UNITED STATES PATENT AND TRADEMARK OFFICE

Office Action Summary	Application No. 10/616,267	Applicant(s) SULLIVAN ET AL.	
	Examiner Ryan J. Severson	Art Unit 3731

DETAILED ACTION

FIG-22

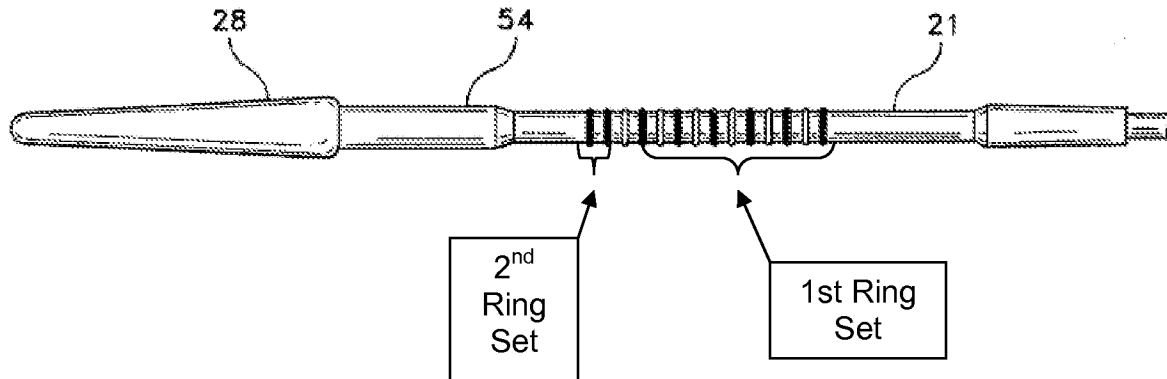
The stabilizer comprises a non-inflatable inner core (21, see figure 22) having a plurality of ring-shaped protuberances that contact the inner surface of the stent (see column 5, lines 13-17) to frictionally engage the stent. This frictional engagement prevents the stent from moving relative to the stabilizer during retraction of the outer sheath. The stabilizer can also include a proximal shoulder not disposed under the stent (as in figure 22). The plurality of rings define two sets of rings (see annotated figure 22 below, where the first ring set is defined by the shaded rings shown below and the second set is defined by the two adjacent rings at the distal end of the stabilizer) wherein each set of rings includes at least two rings, the rings in the first set lie along the length of the stent-underlying portion and are spaced in a first pattern and the rings in the second set lie at the distal end of the stent-underlying portion and are spaced in a second pattern that is different than the first pattern. The rings in the first set are spaced apart twice the distance as the rings in the second set.
